ARCHITECTURAL REVIEW BOARD STAFF REPORT

Project #/Name	ARB-2019-146: Beaver Creek – Medical Office Building Final Site Plan
Review Type	Final Site Development Plan
Parcel Identification	06000000003800
Location	2248 & 2246 Ivy Road, at the intersection with Twin Sycamores Lane (Figures 1-5)
Zoned	Highway Commercial (HC)/Entrance Corridor (EC)/Airport Impact Area (AIA)
Owner/Applicant	West End Shops-West LLC/Turner Enterprises (John Thier)
Magisterial District	Jack Jouett
Proposal	To construct a two-story 26,600 sf medical office building, underground parking and associated site improvements on approximately 1.42 acres.
Context	This portion of Ivy Road is primarily commercial in nature, with strip shopping centers and stand-alone businesses nearby (Figures 6-8). University Heights apartment complex is directly behind (to the south) the subject parcel. Many of the commercial buildings in the vicinity are two stories tall. A significant portion of the adjacent development along Ivy Road predates the establishment of the EC and, consequently, does not meet the requirements of the EC guidelines.

DATE	APPLICATION/REVIEW TYPE	RESULT
10/7/2019	ARB-2019-101: Beaver Creek Medical Office Bui

Figure 10: Initial Site Plan Layout.

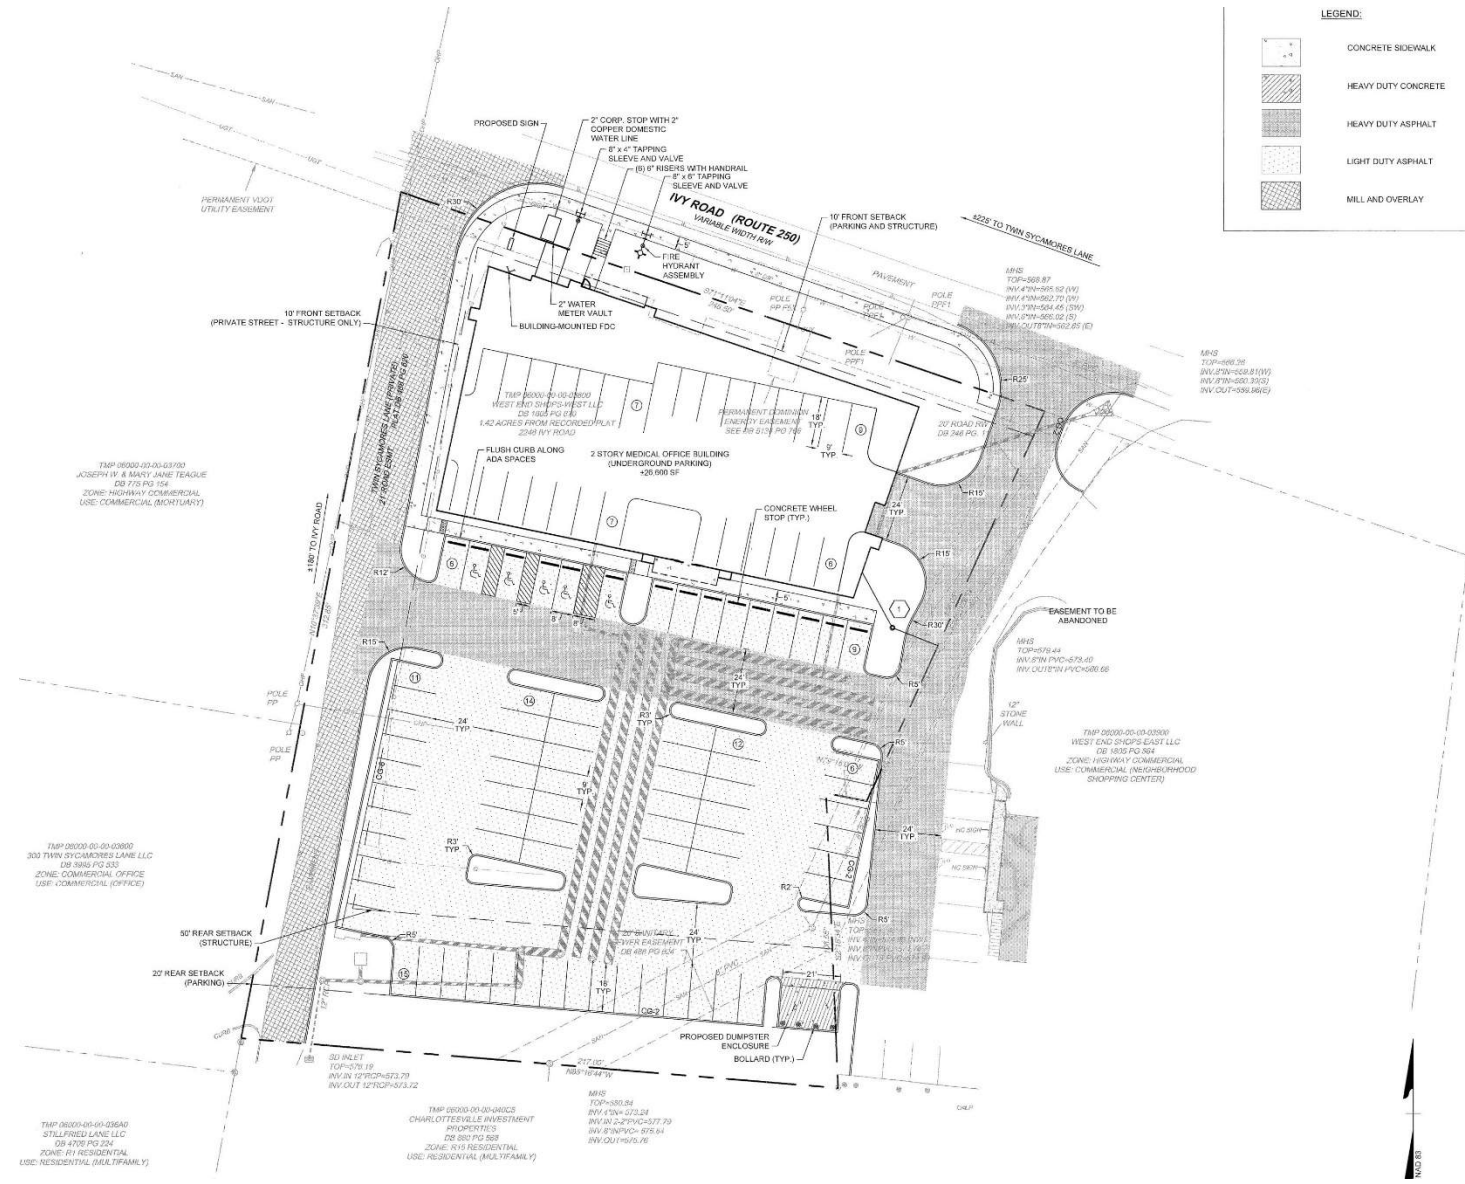
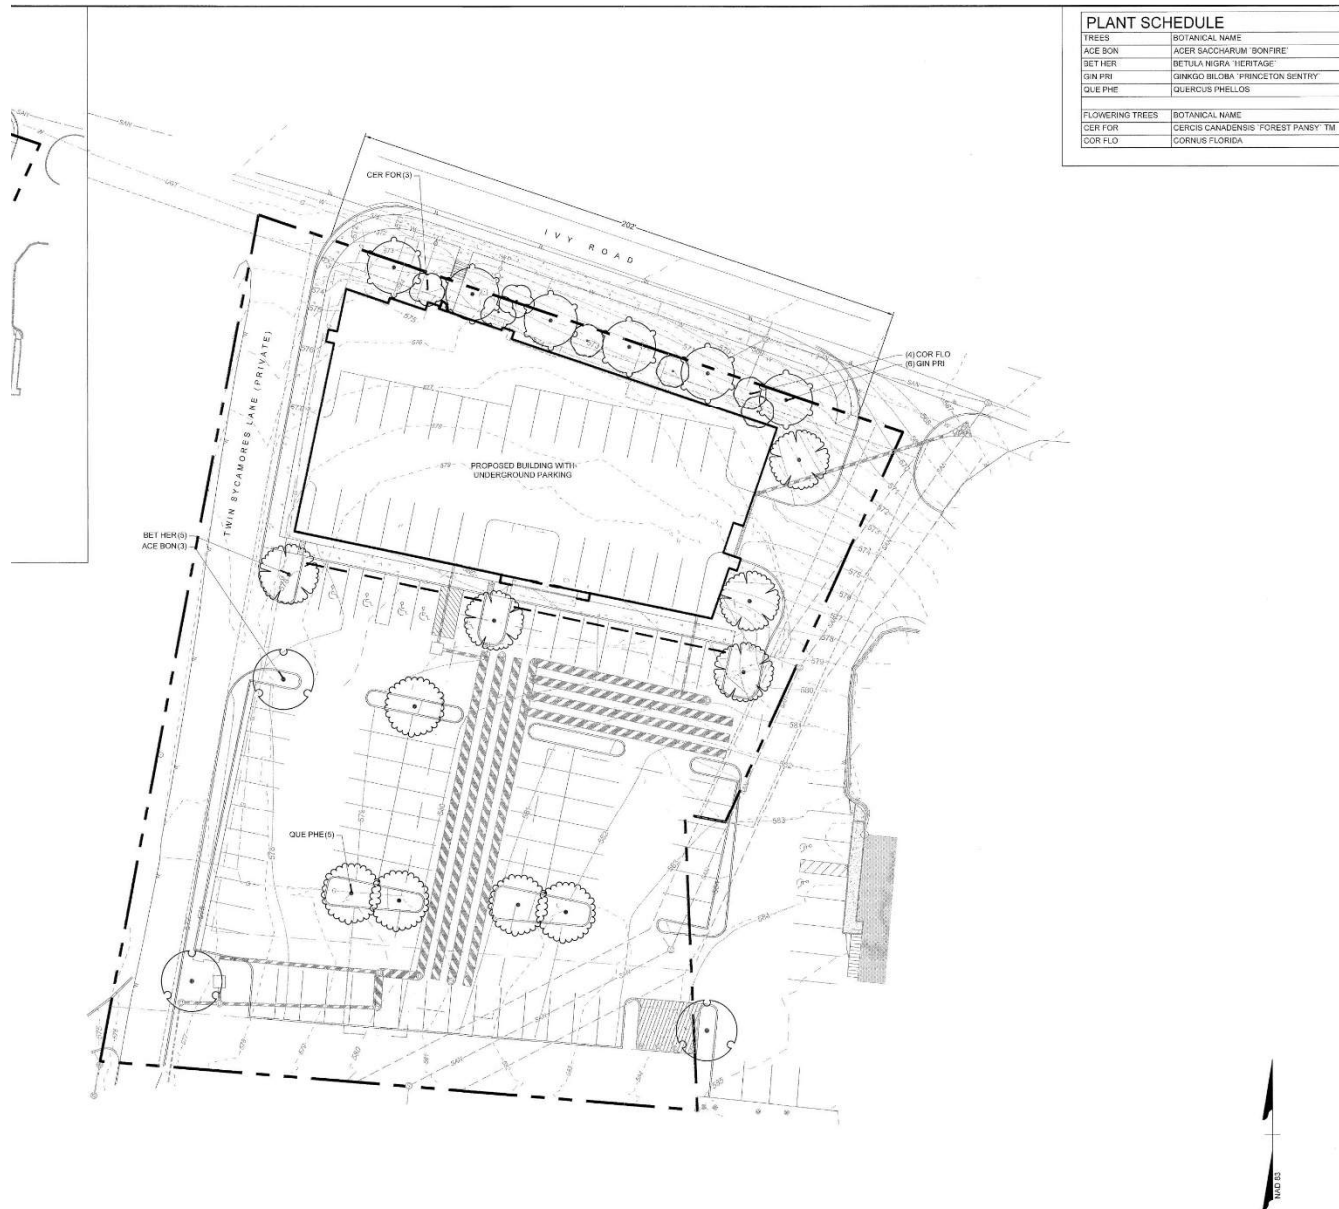
layout of the parking lot has been revised since the initial site plan (Figure 10 & 11). The curb is now proposed 2' from the southern parcel boundary, and a screening fence is proposed between the curb and the property line, leaving no planting area for parking lot perimeter trees. This area is subject to an undisturbed buffer requirement. The applicant is requesting a special exception to disturb the area. The Planning Division considers the screening fence and interior parking lot trees to be an improvement over the existing condition. Given that finding, and the location of the parking behind the building, shifting the perimeter parking trees to interior islands along the southern edge of the parcel is acceptable in this instance. However, two parking lot trees are directly adjacent to the dumpster area and should be relocated to avoid damage.	
37	Plant species: a. Plant species required should be as approved by the Staff based upon but not limited to the <i>Generic Landscape Plan Recommended Species List</i> and <i>Native Plants for Virginia Landscapes (Appendix D)</i>.	None.	The proposed plant species are appropriate.	None.

17. Revise the site plan to add one small tree along the east perimeter of the parking area.
 18. Move the two large trees away from the dumpster to other interior islands within the southern parking row to avoid damage.
